## Video Products Technical Bulletin 30-2004-004

DATE: **January 12, 2004**SUBJECT: **RETRACE LINE ON SCREEN WITH NO HD-SDI INPUT**

MODEL: **PVM-14L5/1**  
**PVM-14L5/2**  
**PVM-20L5**  
**PVM-20L5/1**  
**PVM-20L5/2**  
***PVM-D14L5A***  
***PVM-D14L5A/1***  
***PVM-D20L5A***

**Figure 1**

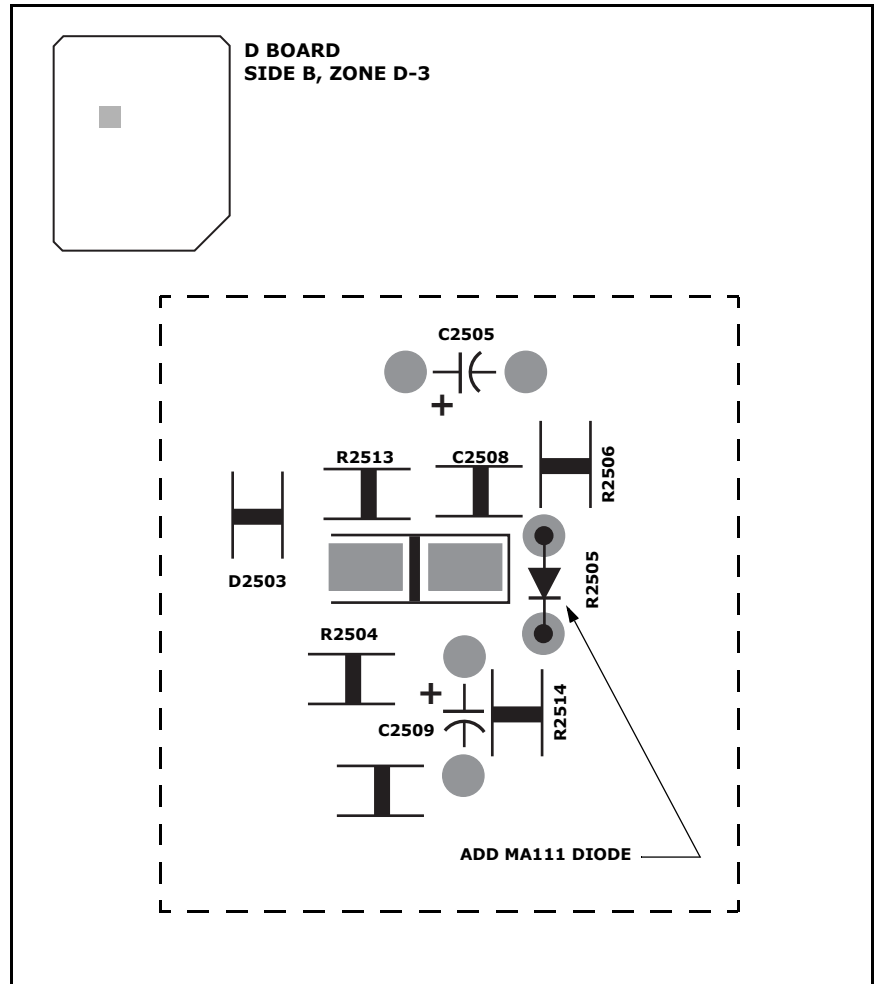
1. Solder an MA111 diode to the pads reserved for R2505. (See Figure 1.)

**Figure 2**

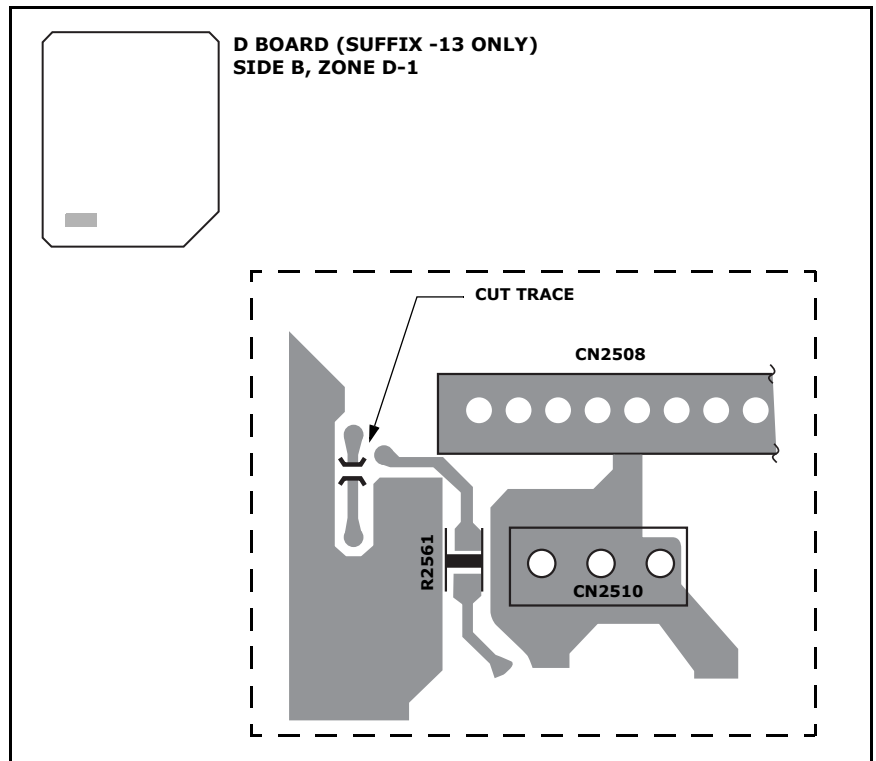
a. Cut the trace as shown in Figure 2.

**Figure 3**

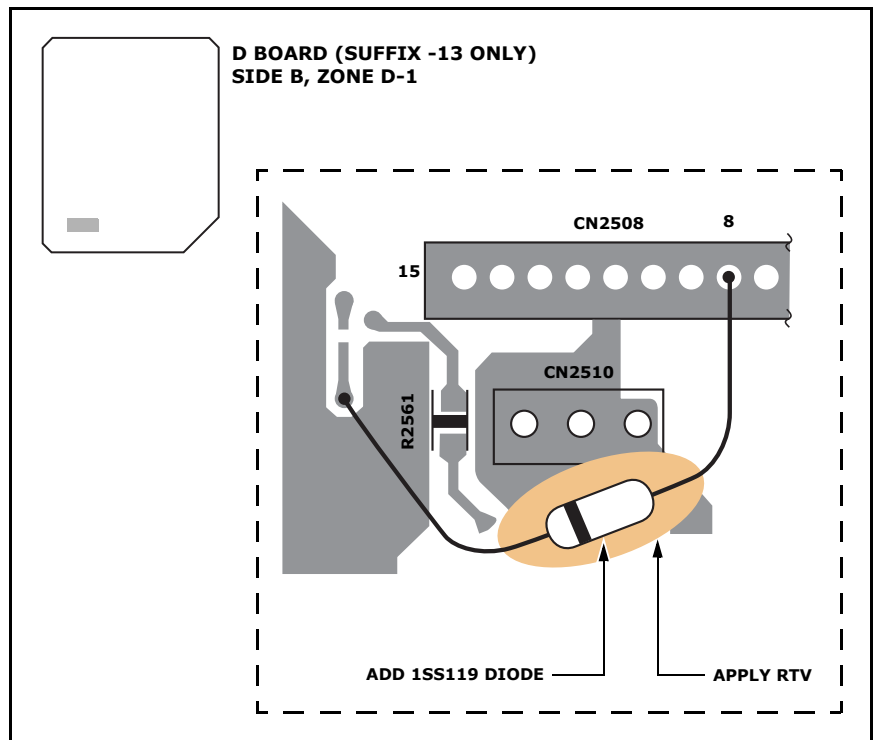
b. Solder a 1SS119 diode between CN2508 pin 8 and the thru-hole, with the cathode of the diode connected to the thru-hole. (See Figure 3.)

**Figure 4**

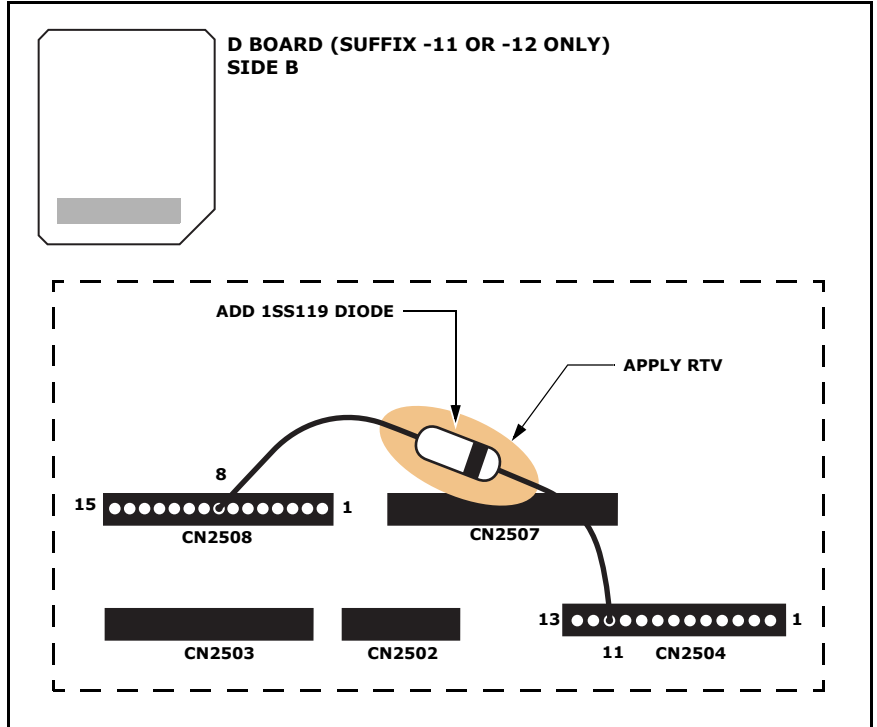
Solder a 1SS119 diode between CN2508 pin 8 and CN2504 pin 11, with the cathode of the diode connected to CN2504. (See Figure 4.)

**Figure 5**

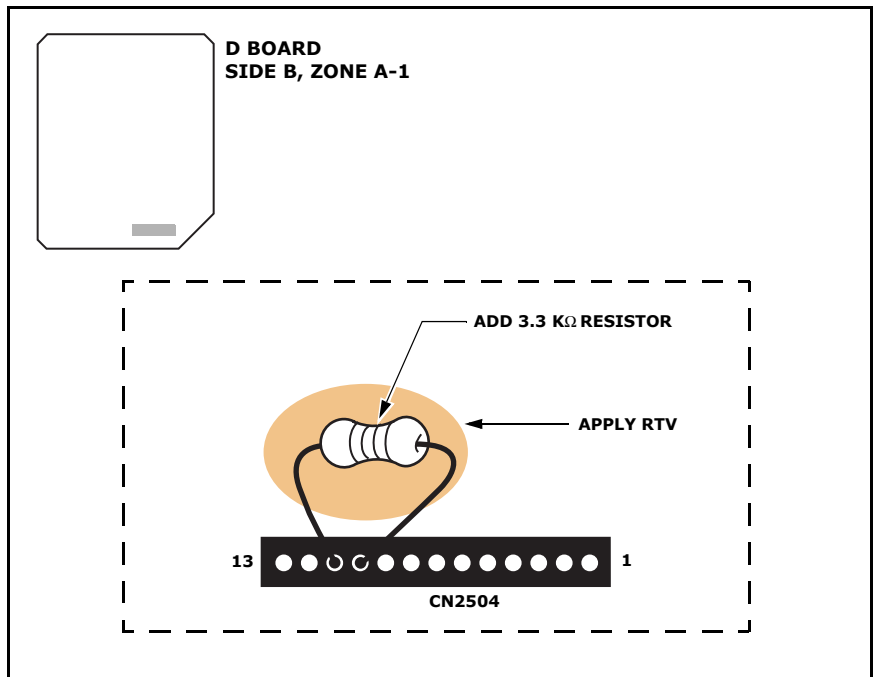
3. Affix the diode to the board with RTV.
4. Solder a 3.3 k $\Omega$  resistor between CN2504 pins 10 and 11. (See Figure 5.)

**Figure 6**

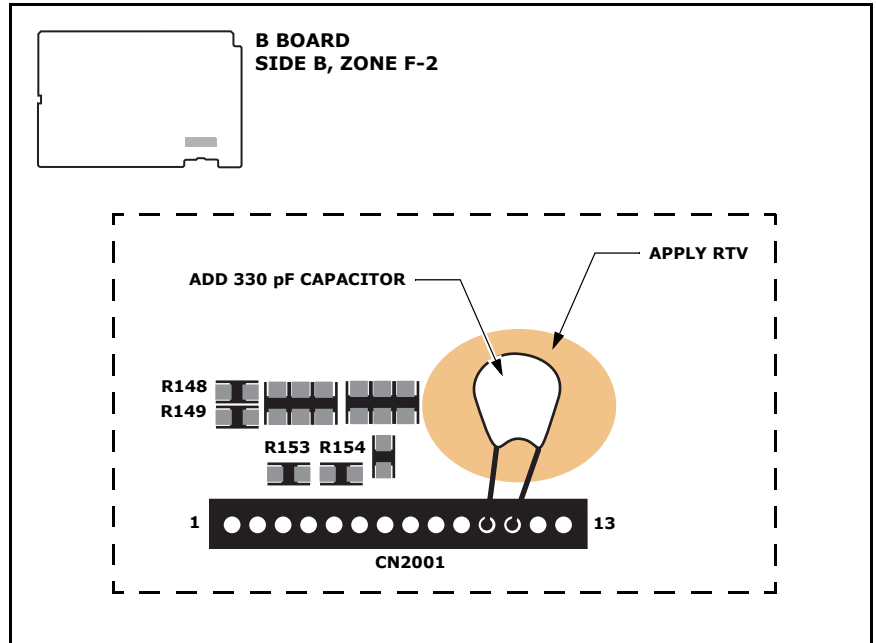
- Solder a 330 pF capacitor between CN2001 pins 10 and 11. (See Figure 6.)

**Figure 7**

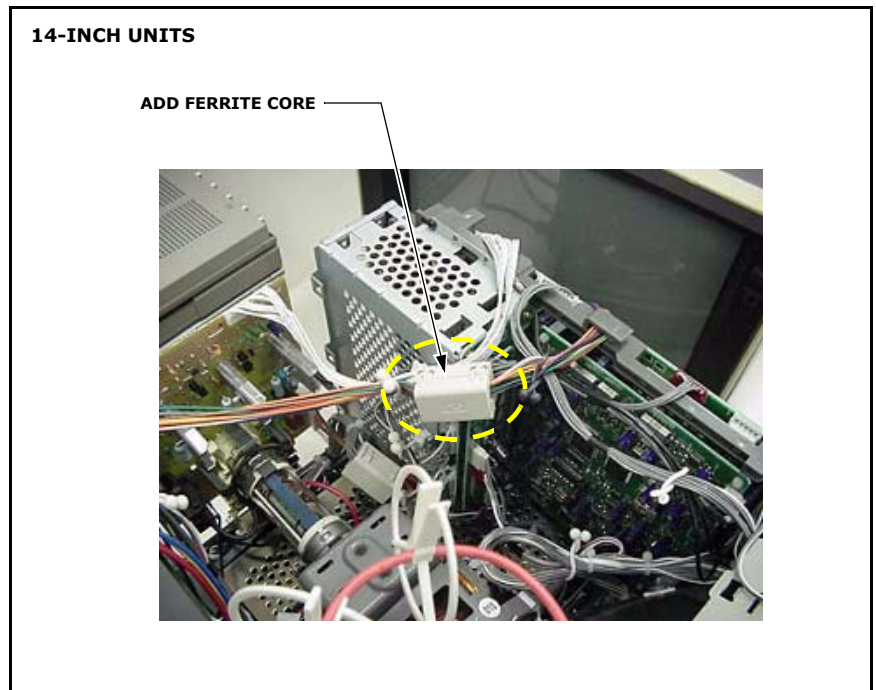
- Affix the capacitor to the board with RTV.
  - Add an SFC-6 ferrite core to the harness connected between CN2001 on the B board and CN2504 on the D board.
- NOTE:** Add the core between the supplied path locks (black and signal block path locks). (See Figures 7 and 8.)
